FINAL SUBSEQUENT
Environmental Impact Report

**South San Joaquin Irrigation District (SSJID)
Plan to Provide
Retail Electric Service,
Sphere Plan, MSR,
and Annexation
(SCH No. 2005102018)**

Prepared for
San Joaquin Local Agency Formation Commission

November 2014

Figure 1: Depletion of \$39 Million Equity Contribution Under CCA

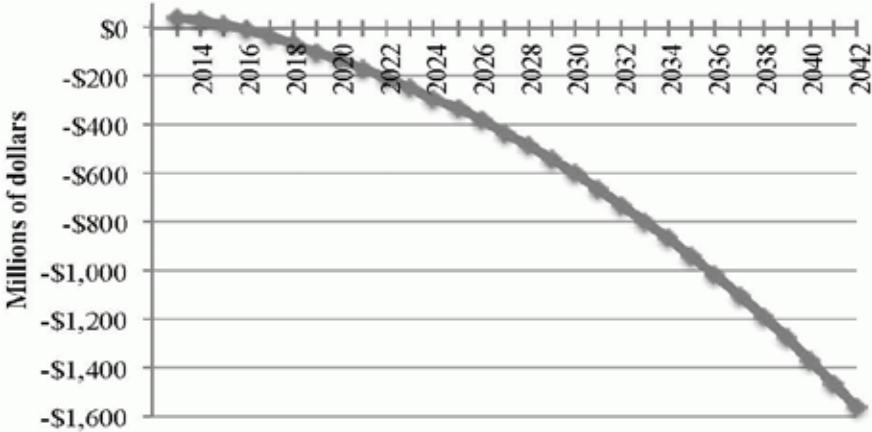
MRW’s analysis of the CCA alternative and the rapid equity depletion under CCA shown in Figure 1 is based on the assumptions used in the PA Report for evaluating SSJID’s business plan for providing retail service, including the same initial and annual equity contributions from SSJID. It includes consideration of SSJID’s primary expenses as a CCA provider, including the cost of power, the cost of exit fees that SSJID would be required to pay to PG&E, and the 15% electric rate discount SSJID intends to provide to its customers. MRW compared these expenses to the CCA revenues which would come from the generation component of customers’ electric bills, SSJID’s annual equity contributions, and interest on SSJID’s remaining funds and then subtracted each year’s loss (i.e., the difference between the CCA expenses and CCA revenues, including the annual equity contributions) from the initial \$39 million equity contribution from SSJID.

Figure 2: Accretion of Reserve Fund Under Municipalization

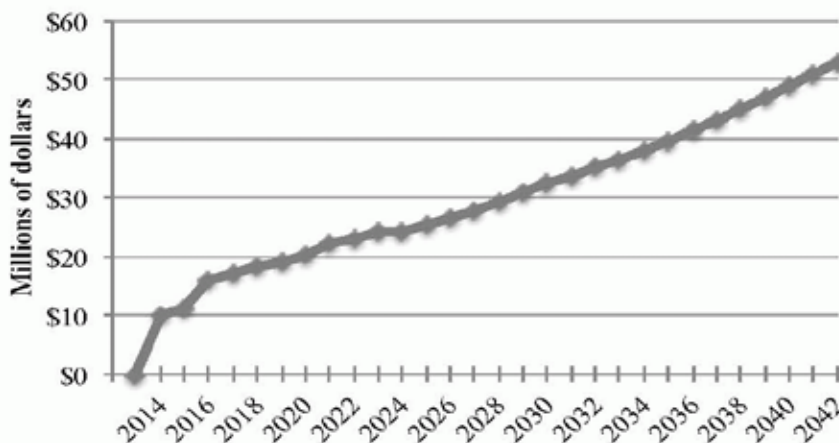
The results of MRW’s analysis of SSJID’s Plan for full municipalization under the same general assumptions are provided in Table 2 for comparison. MRW’s analysis of SSJID’s Plan relies exclusively on the PA Report inputs and incorporates the same inputs used in the CCA analysis, adding in additional revenues and expenses specific to the municipalization scenario. In the municipalization scenario, the \$39 million initial equity investment is used to purchase PG&E’s distribution infrastructure and is not available as a starting balance for a fund. In this scenario, the fund begins at \$0 and grows each year as revenues (including equity contributions from SSJID) exceed expenses. As shown in Figure 2, by the end of 30 years, the fund grows to over \$50 million (as required under the PA Business Plan for use as a reserve fund).

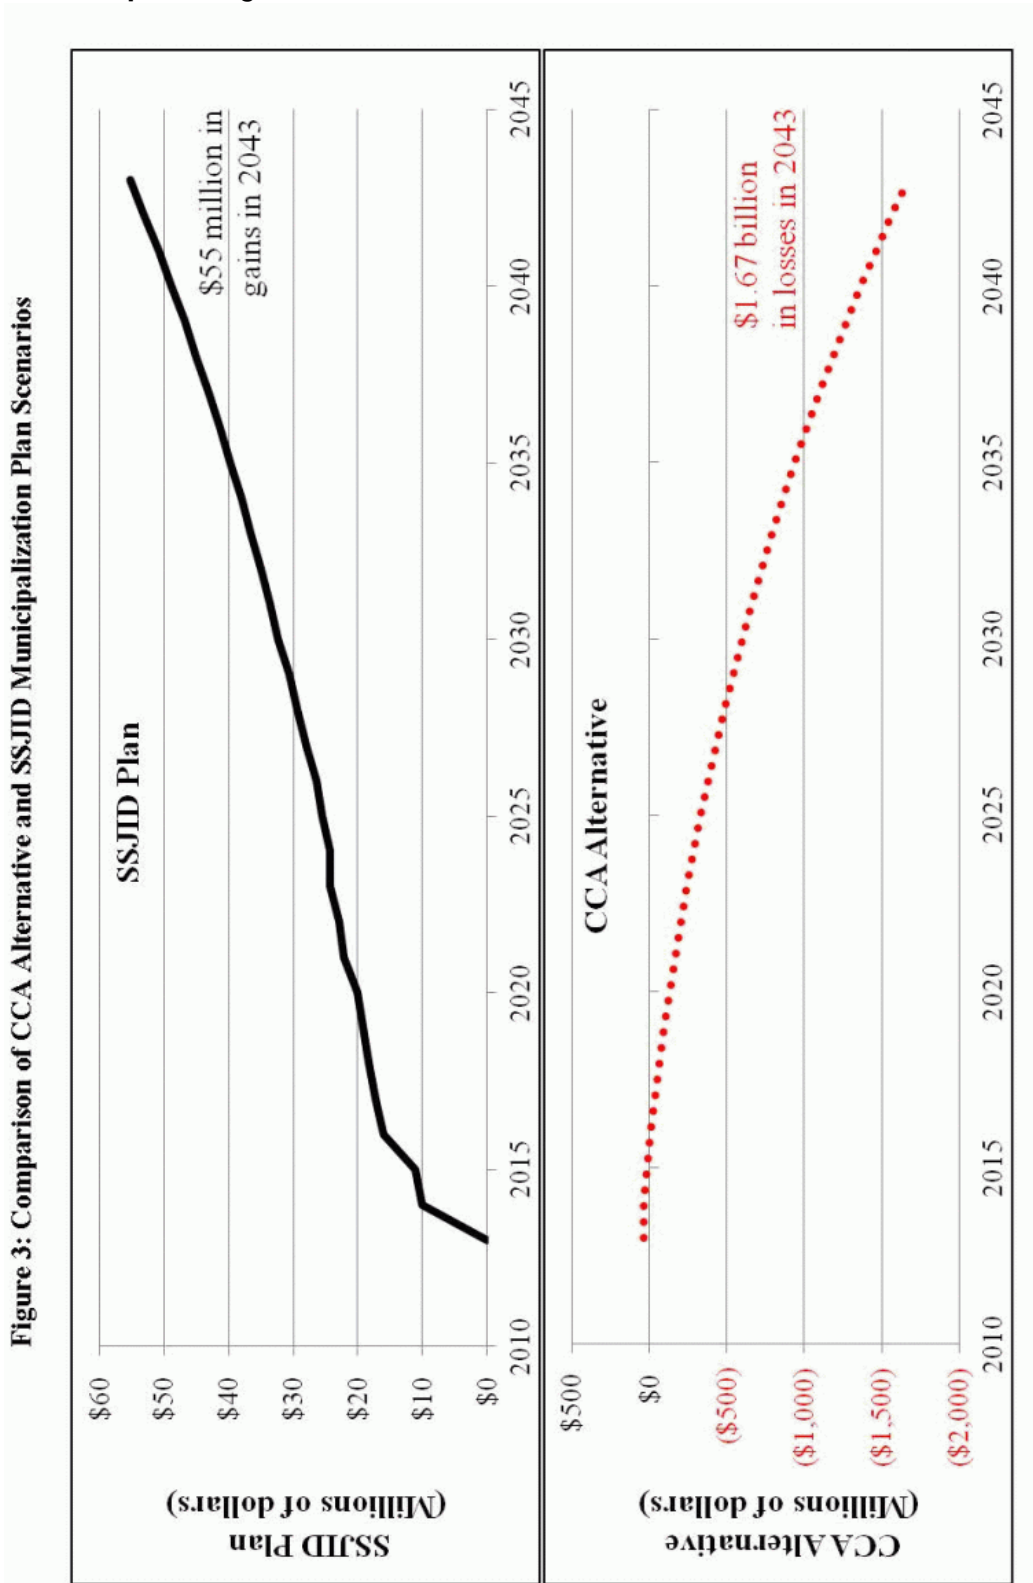
Figure 3 on the following page provides a direct comparison between the CCA and SSJID's Plan. As shown above, under the CCA scenario, an initial \$39 million investment is depleted within a few years, resulting in a deficit of more than \$1.6 billion after 30 years. In stark contrast, under the SSJID Plan for full municipalization, SSJID's fund grows steadily over time to more than \$50 million after 30 years.
